# SERVICE BULLETIN

M-1365

April 7, 2014

## XL FORWARD CONTROL KIT BRAKE PEDAL REPLACEMENT

Figure 1. Brake Pedal

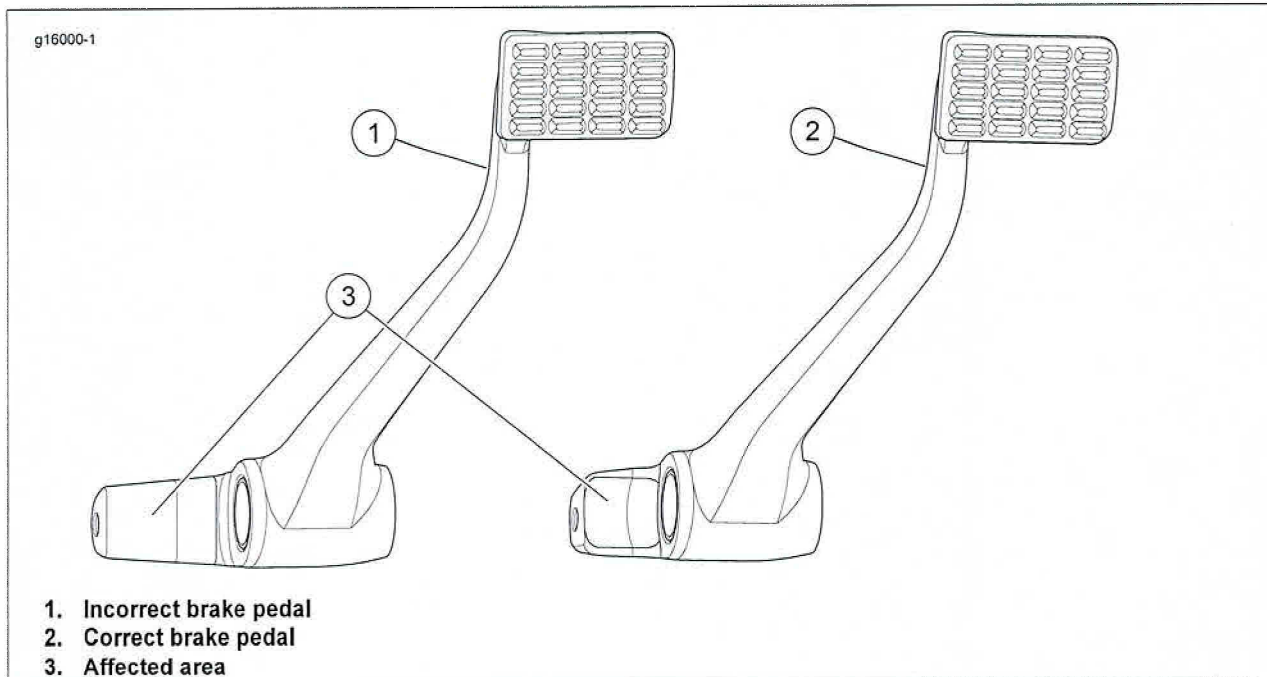
Forward Control Kits (Part No. 50700020), including brake pedal (Part No. 50600111), shipped before February 10, 2014 contained an incorrectly manufactured brake pedal.

1. See Figure 1. Inspect affected area (3) of brake pedal. Correct brake pedal (2) has shorter boss.
2. See Figure 2. When installed, incorrect pedal (2) is in position shown.
3. All kits or brake pedals shipped before February 10, 2014 will require a new brake pedal (Part No. 50600111).
4. Inspect current inventory of Harley-Davidson Forward Control Kits (Part No. 50700020 and brake pedals (Part No. 50600111). Contact any retail purchasers of Part No. 50700020 or 50600111 and inspect pedal. Order new brake pedals as needed.
5. Remove and replace the brake pedal in all affected Forward Control Kits, or component brake pedals in your inventory with a **new** pedal. Contact any retail purchasers of Part No. 50700020 or 50600111 and replace the original brake pedal with the **new** brake pedal.
